# **Improved Transcoding Scheme for 40GBASE-T**

**Addressing Comment #403 to Draft 2.0**

**IEEE P802.3bq, Task Force meeting, May 2015**

# Step-2: Reduce Latency

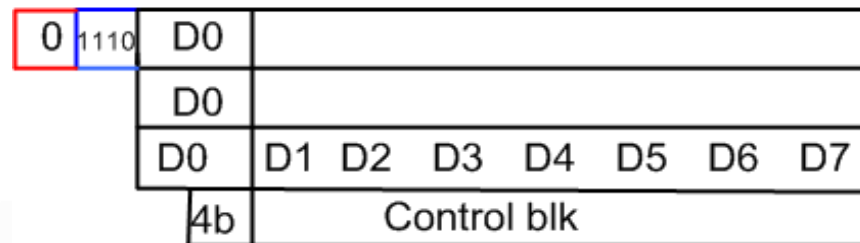
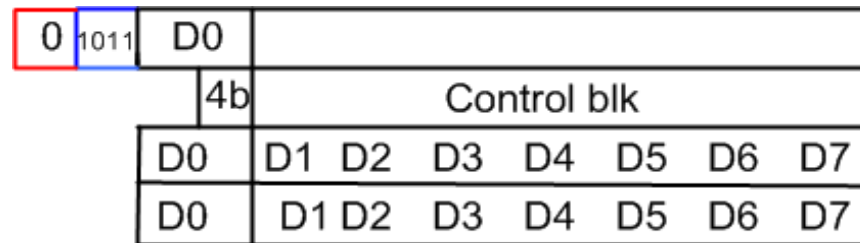
- To reduce processing latency, we transmit the first bytes of every 64-b blocks before sending out the rest 7 bytes of any 64-b block [2].
- In this way, the trans-decoding operation doesn't need to wait until the whole transcoded block of data is received.

# Transcoding of Data Blocks

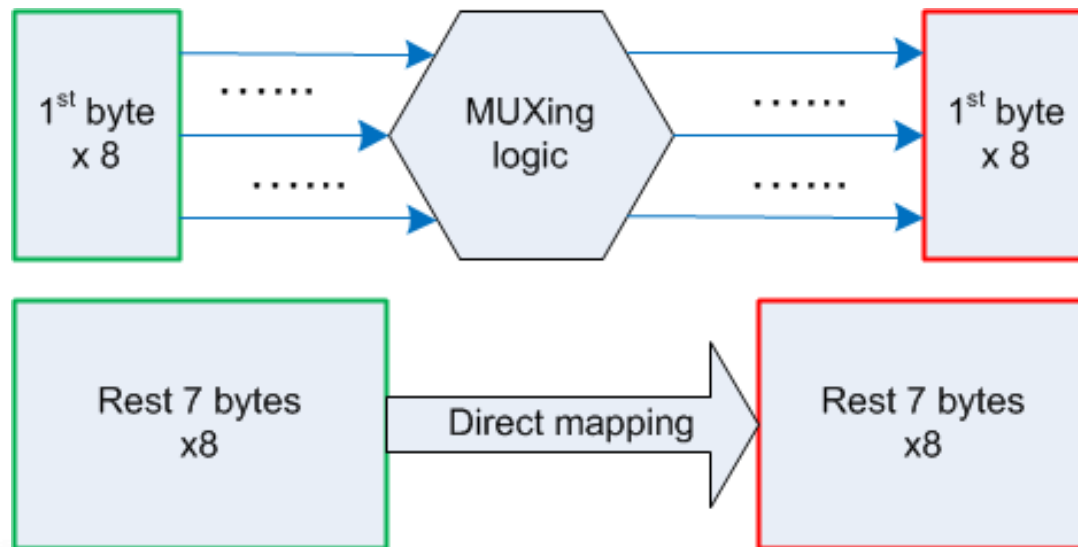
- When dealing with 8 65-b pure data blocks, to ease the implementation, we should first transmit the first byte of each 64-b block as we did for those cases with one or more control blocks.
- In this way, there are **fixed mapping locations** for each 64-bit block except the first byte.
